CASE NO. 2020-00043
GLOVER CREEK SOLAR, LLC
RESPONSES TO HARVEY ECONOMIES' FIRST REQUEST FOR INFORMATION

II Site development plan—We need to resolve some conflicting information provided about the site development and to better understand certain elements in that site plan.

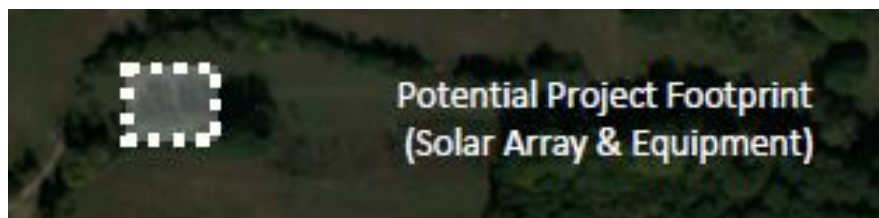
- B. How many solar panels will be installed on-site? How many transformers? Please confirm that there will be 13 energy storage systems (co-located with the 13 inverters).

The image below shows a typical configuration of inverter and transformer using string inverters. The white boxes are the string inverters, and the grey box sitting on a pad at the end of the inverter string is the transformer. At Glover Creek, this configuration

will also have an energy storage system housed within 2 or 3 containers, installed on a separate pad adjacent to the inverter and transformer.

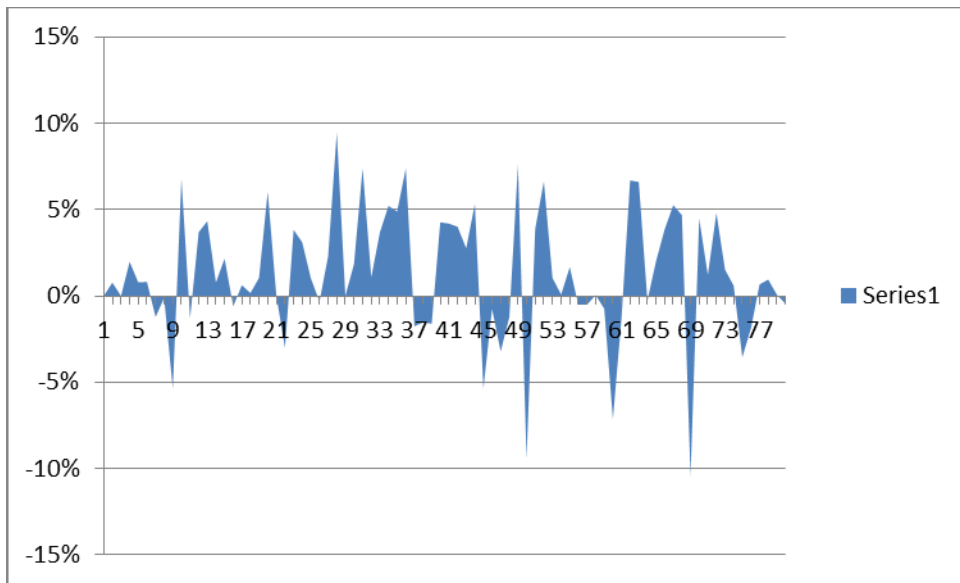
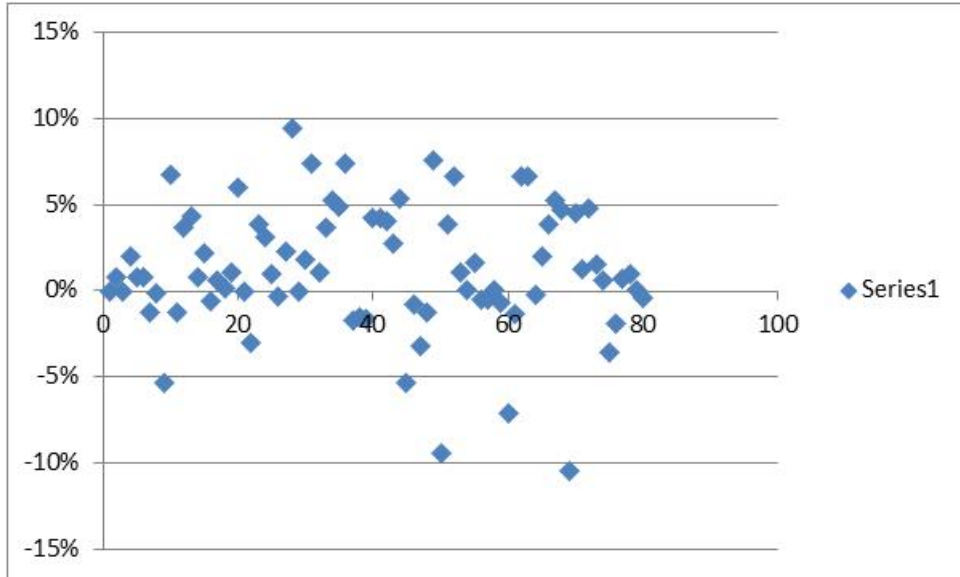
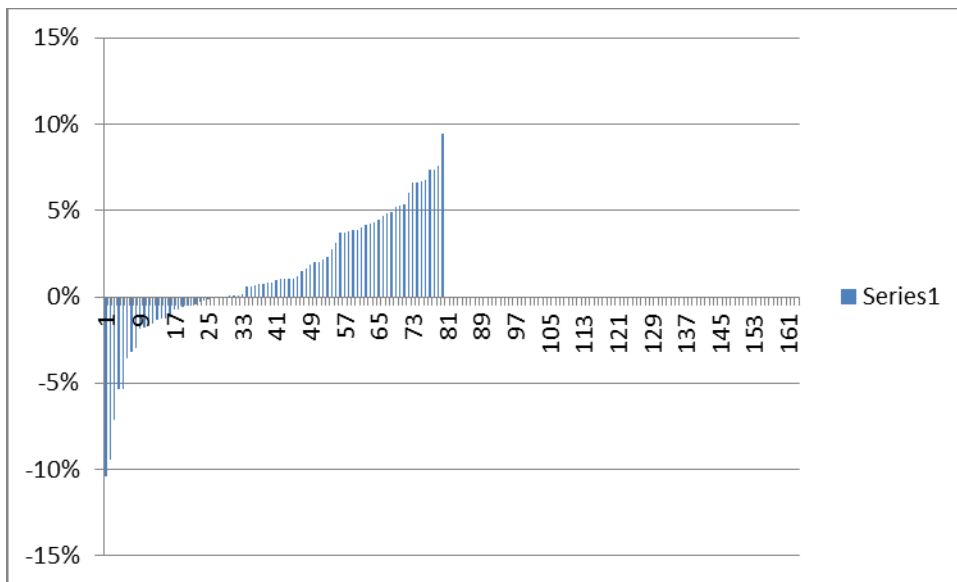
4- I was asked about the 37 solar farms and the 81 matched pair sets and how I chose those. This is the total of all the usable home and land sales adjoining the 650 solar farms that I have looked at over the last 9 years. Most of the solar farms that I have looked at are only a few years old and have not been in place long enough for home or land sales to occur next to them for me to analyze. There is nothing unusual about this given the relatively rural locations of most of the solar farms where home and land sales occur much less frequently and the number of adjoining homes is relatively small.

Essentially, I go back through the solar farms that I have looked at roughly once a year to see if there are any new sales. If there is a sale I have to be sure it is not an inhouse sale or to a related family member. A great many of the rural sales that I find are from one family member to another, which makes analysis impossible given that these are not "arm's length" transactions. There are also numerous examples of sales that are "arm's length" but are still not usable due to other factors such as the adjoining coal fired plant noted in Question 2. I have looked at homes that require a driveway crossing a railroad spur, homes in close proximity to large industrial uses, as well as homes adjoining large state parks, or homes that are over 100 years old with multiple renovations. Such sales are not usable as they have multiple factors impacting the value that are tangled together. You can't isolate the impact of the coal fired plant, the industrial building, or the railroad unless you are comparing that sale to a similar property with similar impacts. Matched pair analysis requires that you isolate properties that only have one differential to test for, which is why the type of sales noted above are not appropriate for analysis.

So once I go through all of the sales and eliminate the family transactions and those sales with multiple differentials, I am left with 81 matched pairs to analyze. The only other sales that I have eliminated from the analysis are home sales under \$100,000, which there haven't been many such examples, but at that price range it is difficult to identify any impacts through matched pair analysis. As can be seen from a later question, I have not cherry picked the data to include just the sales that support one direction in value, but I have included all of them to see where the data takes me.

Exhibit D

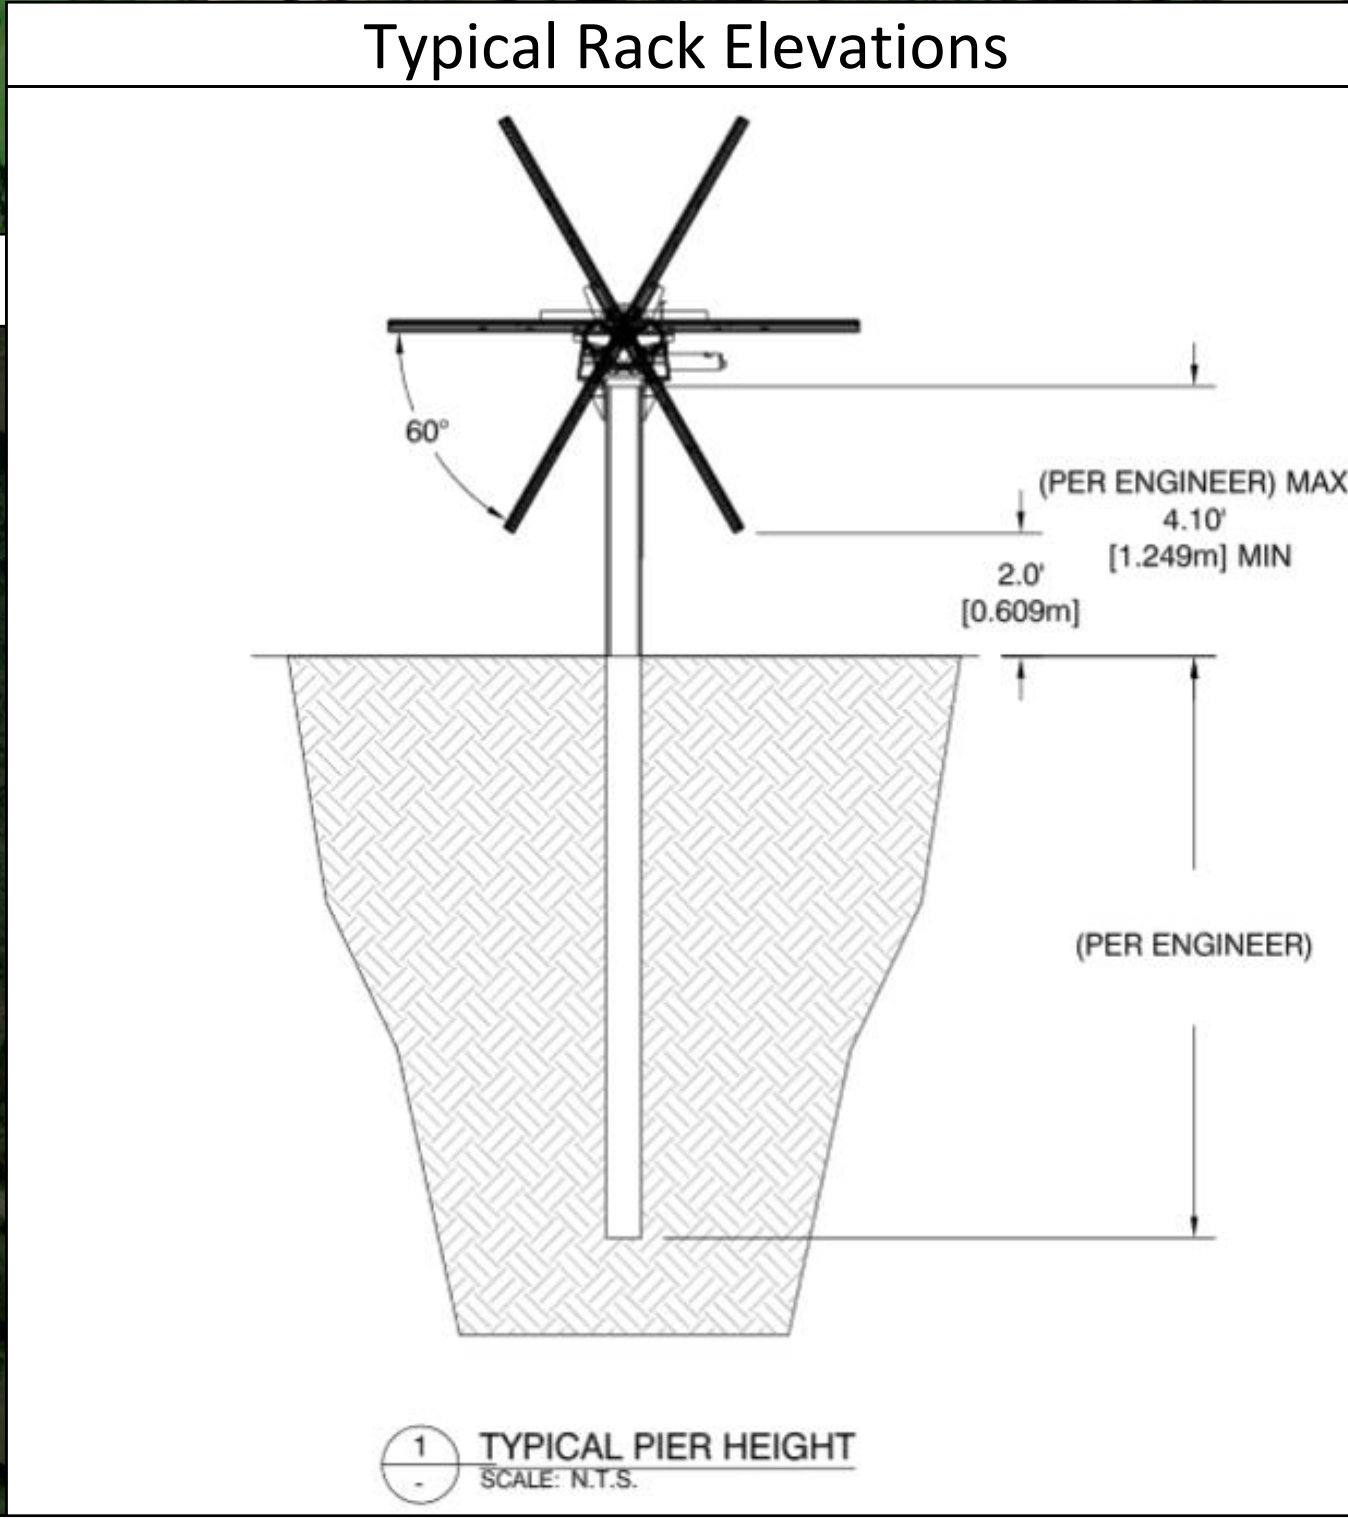
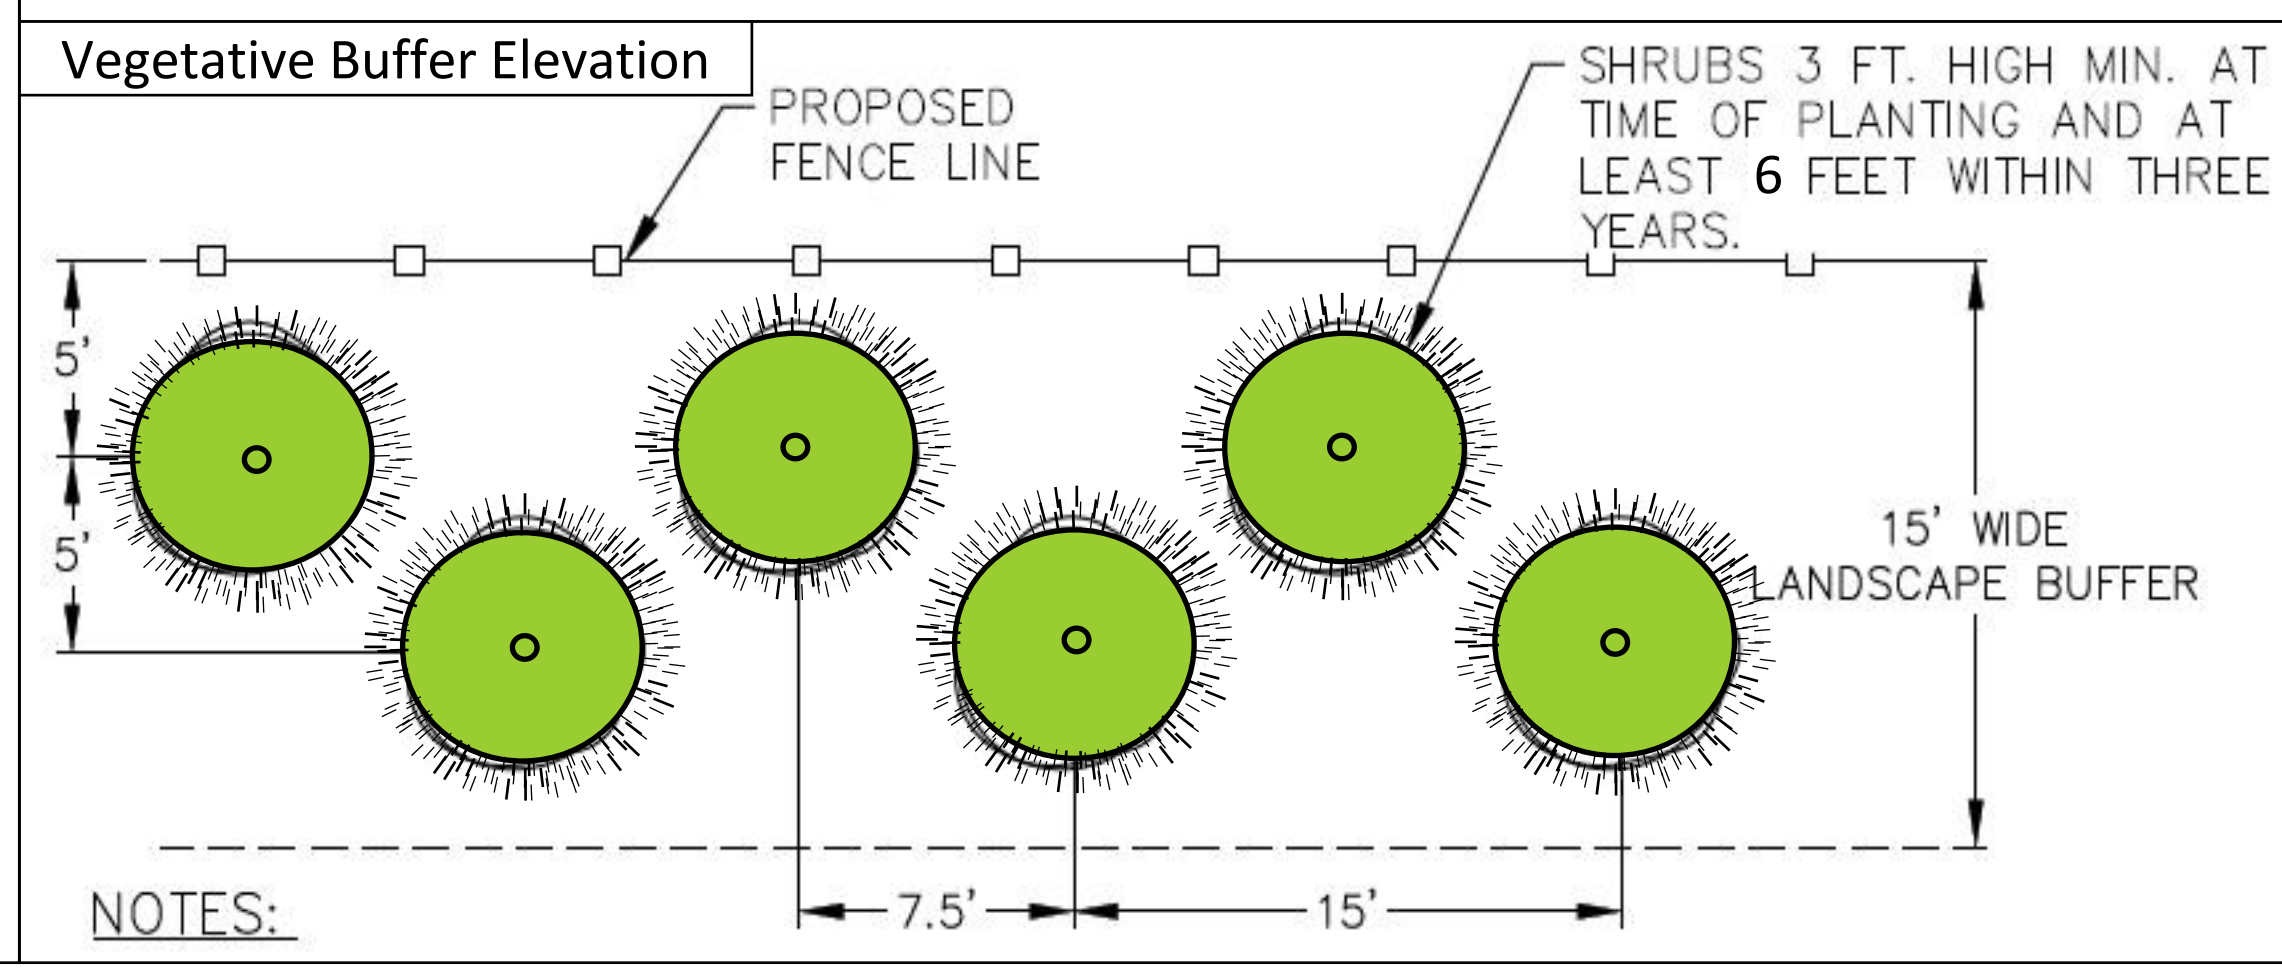
- E. The SAR on page 4 states that “the property boundary includes an additional entrance not included in the layout. This additional entrance was discovered during the property boundary survey.” Please provide a written description and illustration of where that entrance is located. Will that entrance be used by construction vehicles or during operations? If not, how will that entrance be controlled?

- F. Preliminary site layout graphics or need for additional maps:
 - 1. Please clearly identify all access points/ entrances/ access roads to the site.

- 2. Note 5 on the Preliminary Site Layout graphics, pages 315 and 316, indicate a proposed construction staging area - please identify the location of the construction staging area on a map.

- E. Please see Exhibit D for a corrected version of this page; all entrances are shown on the layout.
- F.
 - 1. Please see attached Exhibit D for an updated site plan that clearly identifies all access points, entrances and access roads.

- 2. The construction staging area will likely be located near one of the two construction entrances (i.e. the entrance on Randolph Summer Shade Road or the entrance on Summer Shade Road.) Please refer to Exhibit D for the layout with both entrances labeled.
